SERVICE BULLETIN

NO. 840A

Date: November 7, 2013

FUEL SELECTOR VALVE COVER REPLACEMENT

Figure 1

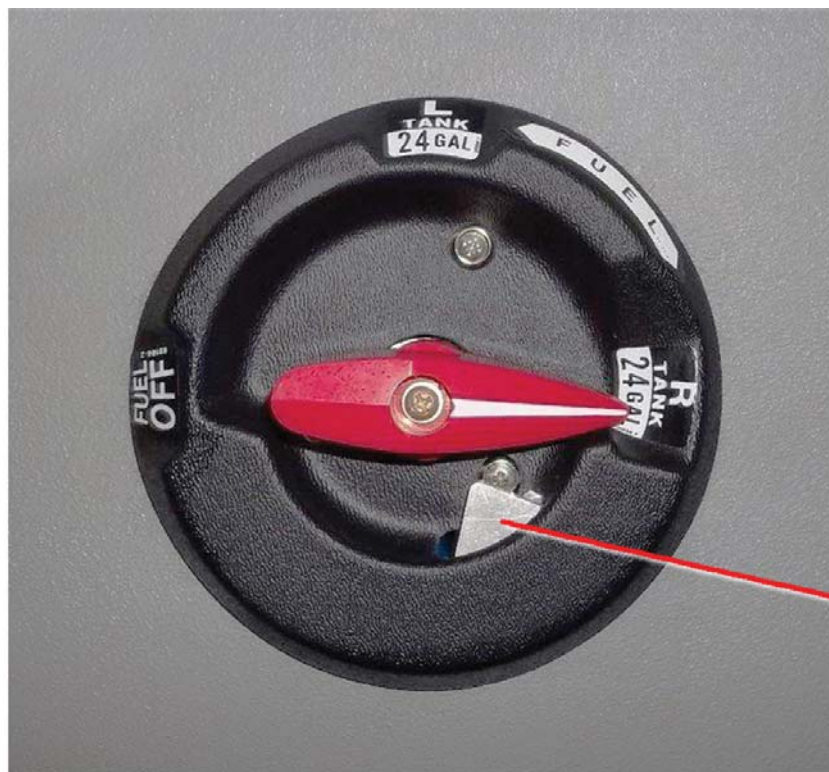
To announce the availability of a new fuel selector valve cover assembly and mating handle, which reduces the possibility of pilot mismanagement of the fuel system through inadvertent selection to the "OFF" position, resulting in power interruption or stoppage.

SPRING LOADED
METAL STOP, PROTRUDING
THROUGH AN OPENING
IN THE COVER

Kits 760-545 and 760-546, shown properly installed.

NOTE: Figure 1 shows proper installation of Piper Part Numbers 760-545 and 760-546. P/N 760-545 is similar to 760-546, except 760-545 includes additional parts and instructions to accommodate an adjacent cabin air vent (cabin air vent not shown in Figure 1).
